# LANDMARKS BOARD

## AGENDA FOR REGULAR MEETING

November 17, 2025

**STAFF REPORT**  
**WINDOWS**  
**123 NORTH MAIN STREET**  
**CASE NO. EC-2025-062**

**Figure 1: 123 North Main Street seen currently, showcasing the six subject windows for replacement.**

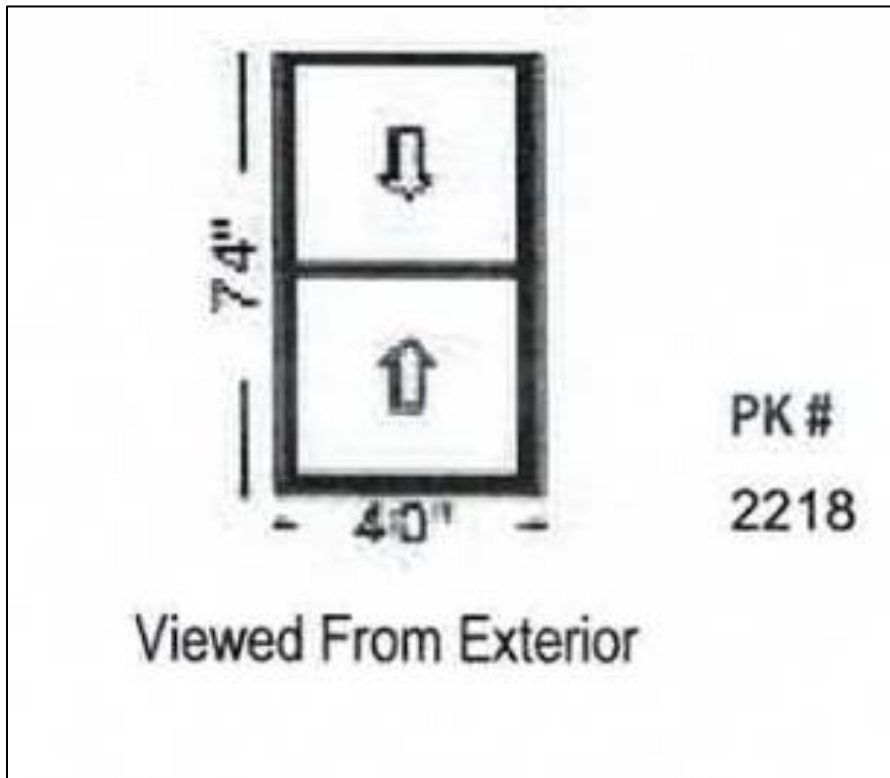
The applicant is proposing to replace four (4) windows on the second floor and two (2) windows on the first floor of the front facade. Similar to the window replacement approved in August this year, the existing wood double hung windows on the front are to be replaced with like-for-like windows in grid pattern, size, and color. It should be noted that the half-moon windows over the two first floor windows and the windows surrounding the front door are not being proposed for replacement. Staff finds the replacements to align with the guidelines for the district and will have no adverse impact on the contributing status of the building or the streetscape. Therefore, Staff recommends approval of the window replacements, as submitted.

**Motion to approve the replacement of six windows on the front facade at 123 North Main Street, as submitted.**

**Figure 2: Example of proposed TimberTech composite decking.**

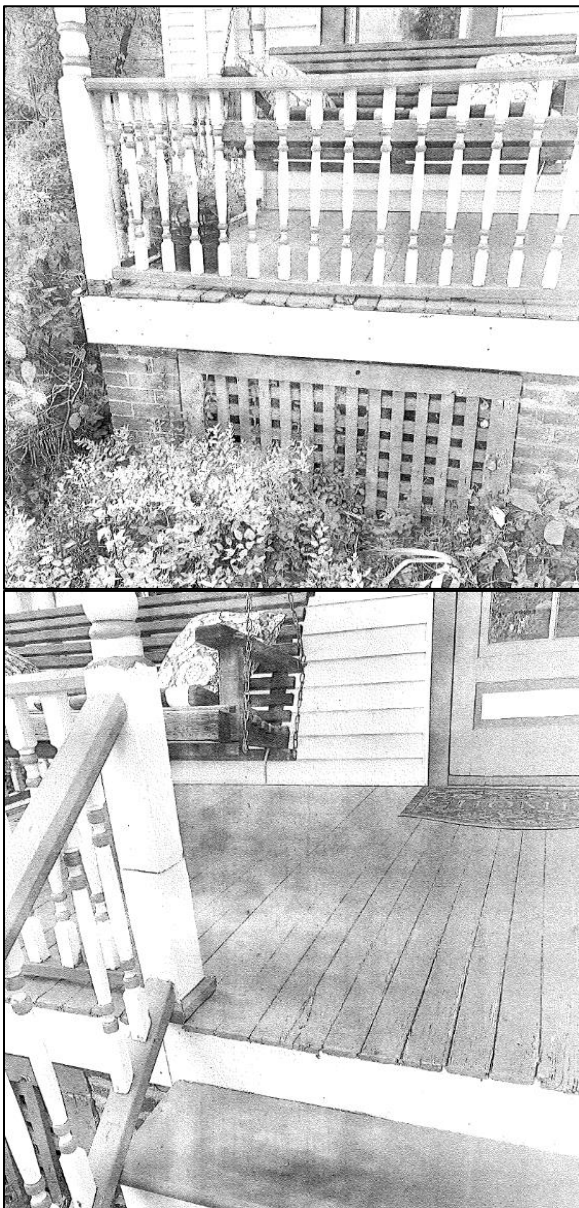
The subject property is 415 Houston Street located in the Extended Historic Preservation District. The two-story, frame, Folk Victorian was built in 1900 and retains much of its original design. The applicant is requesting approval to replace the existing front porch flooring, which has become deteriorated over time. While this work generally does not require review and approval by the Landmarks Board; the applicant has been selected for a Façade Grant and must receive Landmarks Board approval before the Façade Grant Application may be approved. Material examples and photographs of the house accompany the application.

**Figure 1: Proposed signage on building.**

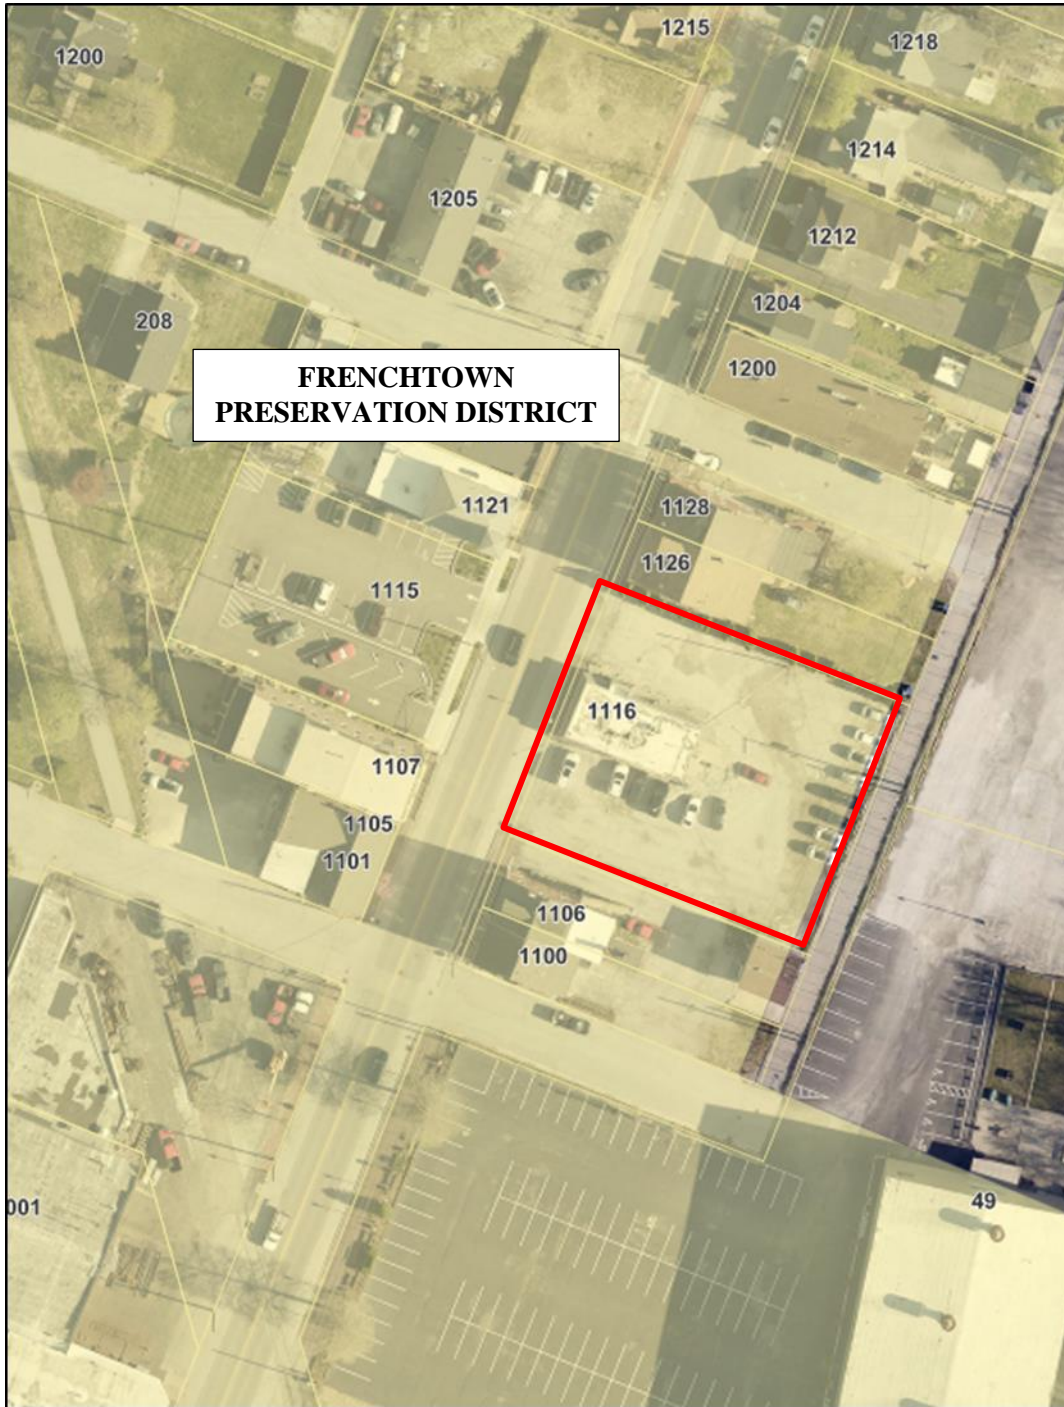
- 7.3 A sign shall be in character with the material, color and detail of the building.
  - a. Simple letter styles and graphic designs are more appropriate on many of the restrained, vernacular structures found on North Second Street.

**Motion to approve the installation of a wall-mounted sign for the Naked Tiki Distilling at 1116 North Second Street, as submitted.**

**Figure 1: 1116 North 2<sup>nd</sup> Street seen currently from the street.**

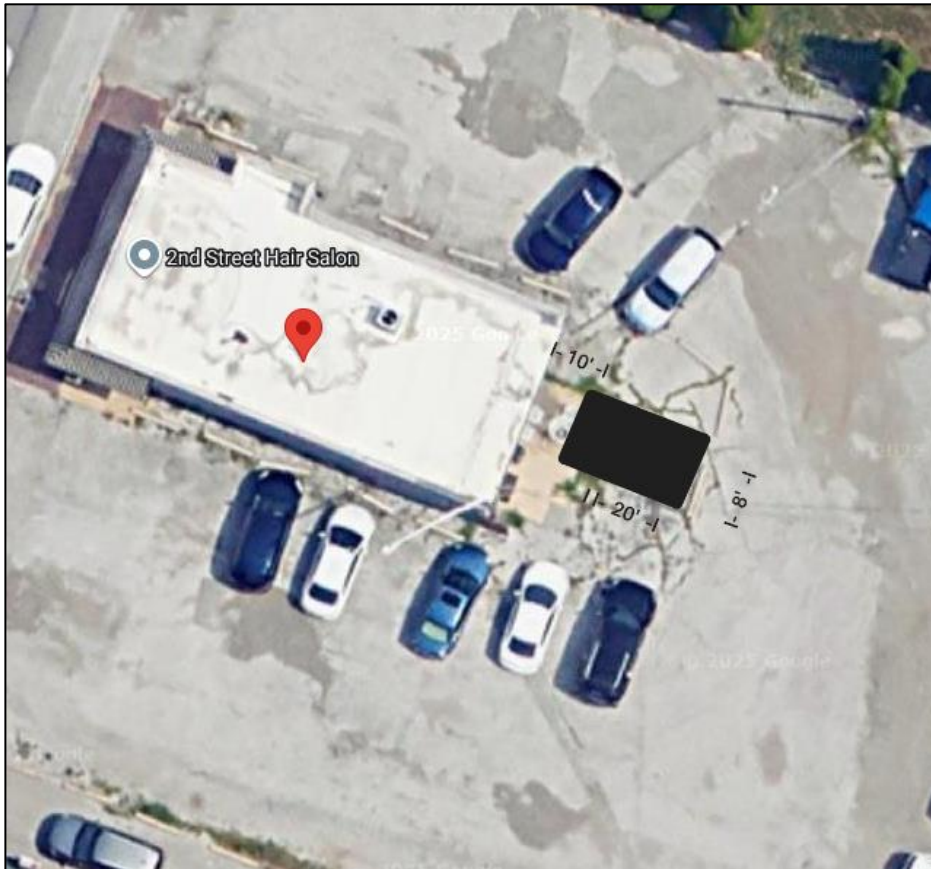
Aesthetically, the container will be painted a beige color, consistent with the approved color for the primary structure. Being located behind the primary structure, the shipping container will be minimally visible from the public right-of-way. The applicant has indicate that this storage solution is temporary, with future plans to construct a permanent rear addition to accommodate both distillery operations and product storage. Given the temporary nature of the proposal, compliance with safety codes, and minimal visual impact to the surrounding area, Staff recommends approval of the request, subject to the following conditions:

**Motion to approve the placement of a storage shipping container in the rear of 1116 North Second Street, subject to the conditions recommended by Staff.**

Figure 3: North elevation showcasing proposed addition.

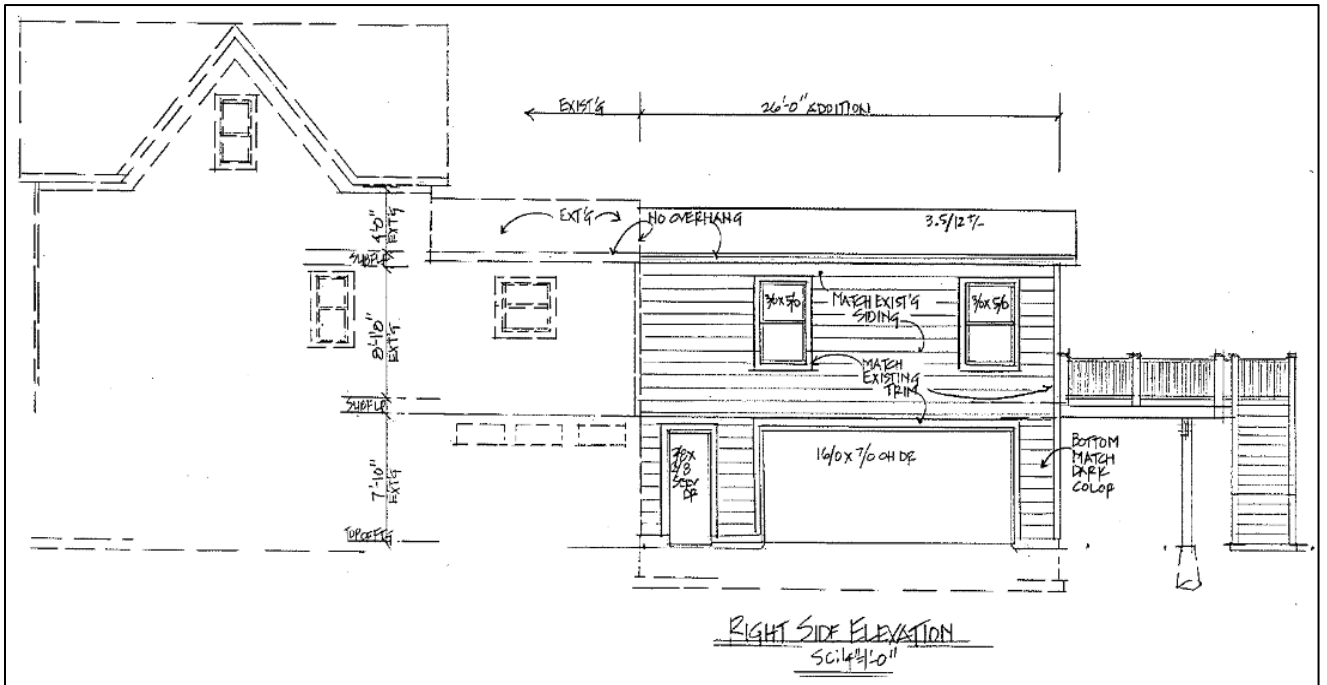
The proposed addition will replace the existing enclosed rear porch and tiered deck at the back of the primary structure. The new construction will utilize materials consistent with the existing dwelling, including matching siding, roofing shingles, and double-hung one-over-one windows. A wood deck and stairway will extend from the second floor where a sliding door is proposed to allow access. The applicant plans to install porch lights adjacent to the sliding door and has chosen designs appropriate for the historic character of the home. The ground level of the addition will feature a man-door below the deck, and white paneled overhead-garage doors oriented toward Lewis Street and served by a paved driveway. Due to the proposed new concrete driveway extending from Lewis Street, the applicant will be required to obtain a right-of-way permit from the Engineering Department for review and approval of the proposed curb cut location.

**Figure 1: Aerial view of subject property showcasing after-the-fact improvements.**

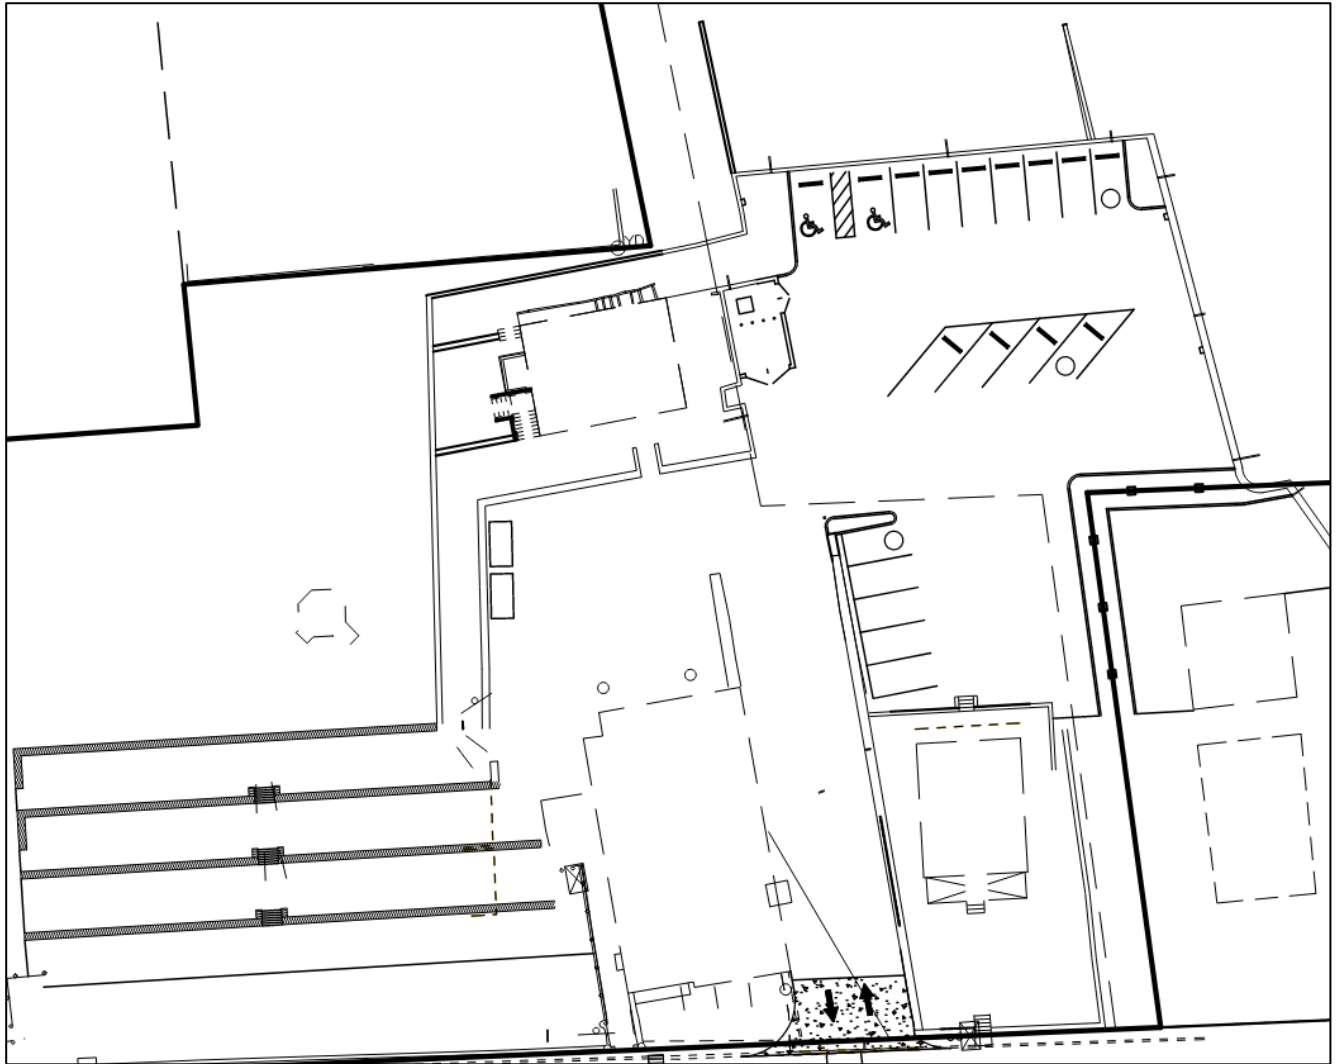
All parking lots with ten (10) or more parking stalls are required to provide lighting. The applicant is proposing wall pack fixtures that feature a more contemporary design than what is typically found in the district (Figure 4, Page 7). However, given that the parking lot is located at the rear of the property and out of public view, and that the lot itself is a newly developed portion of the property, the use of modern lighting fixtures is considered appropriate. The contemporary design will help differentiate the new parking area from the site's historic features. While staff has not received a photometric plan to verify compliance with the City's lighting standards, this can be reviewed for compliance upon submittal of a building permit. Should the proposed lighting be deficient and alternate light fixtures be needed, additional Board review may be needed. Staff has provided a recommended condition of approval to address this matter.

**Motion to approve the after-the-fact improvements at 1219 S. Main Street, subject to the conditions from staff.**
